Proposal for amendments to ECE/TRANS/WP.29/GRVA/2020/21

Proposal for a Supplement to the 11 series of amendments to UN Regulation No. 13 (Heavy vehicle braking)

Submitted by the expert from the European Association of Automotive Suppliers*

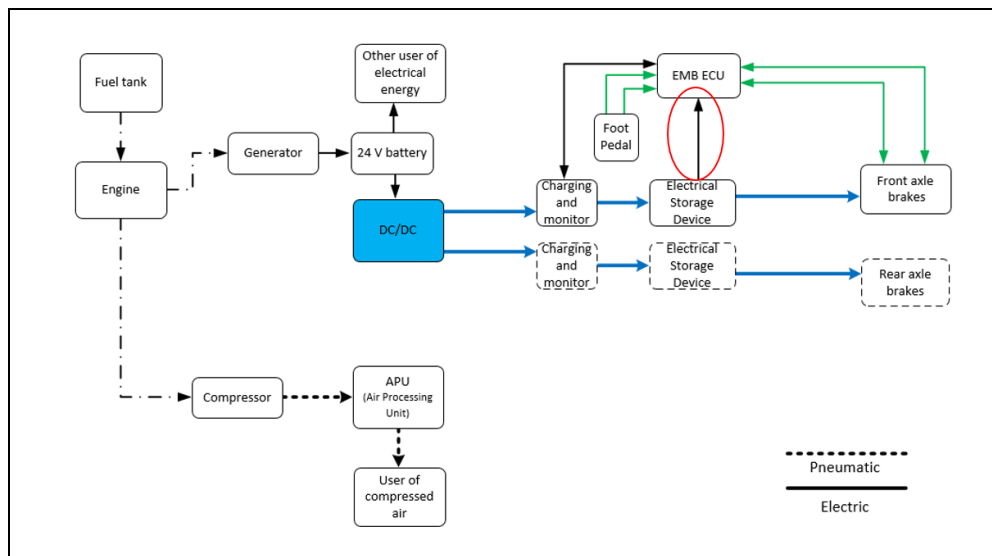
- 5.2.1.34.5.** With an electrical energy supply feeding only the electric control transmission and in the event of a failure of **that supply the energy source of the electric control transmission**, starting from the nominal value of the energy level, the full control range of the service braking system shall be guaranteed after twenty consecutive full stroke actuations of the service braking control. During the test, the braking control shall be fully applied for 20 seconds and released for 5 seconds on each actuation. It should be understood that during the above test, sufficient energy is available in the energy transmission to ensure full actuation of the service braking system. This requirement shall not be construed as a departure from the requirements of Annex 7, Part D.

40. Paragraph 5.2.1.34.5. addresses a configuration of an electro-mechanical braking system where an electrical energy storage device (e.g. battery) **only** supplies energy to the **control** transmission (but **not** to the electrical energy transmission as in the case with an EBS which has to comply with paragraph 5.2.1.27.5.); as an exemplary braking system see figure in paragraph 5.2.1.34.5.).

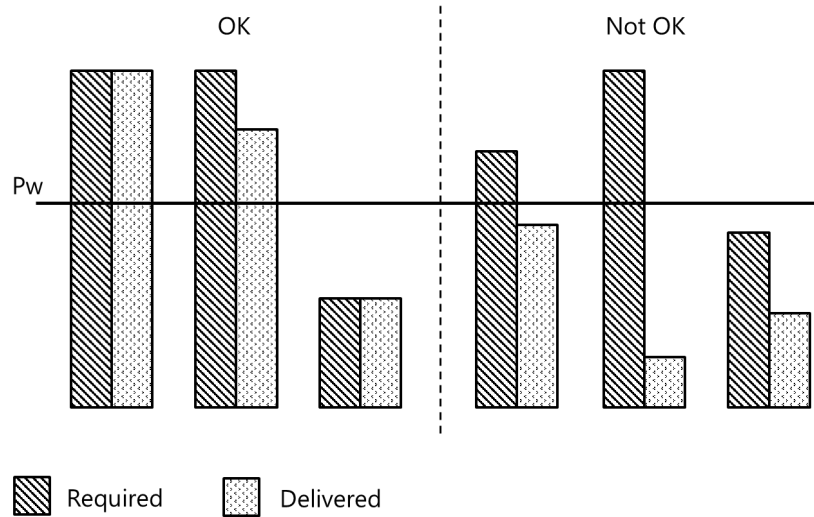
5.2.1.34.6. In the case that the electrical energy storage devices are also providing electrical energy for the electrical control transmission, the requirements of paragraph 1.2.1. of Part D of Annex 7 shall apply.

41. In contrast to paragraph 5.2.1.34.5., this requirement addresses a configuration of an electro-mechanical braking system where energy storage devices are providing electrical energy for the electrical control and electrical energy transmission; as an exemplary braking system see figure in paragraph 5.2.1.34.6.).
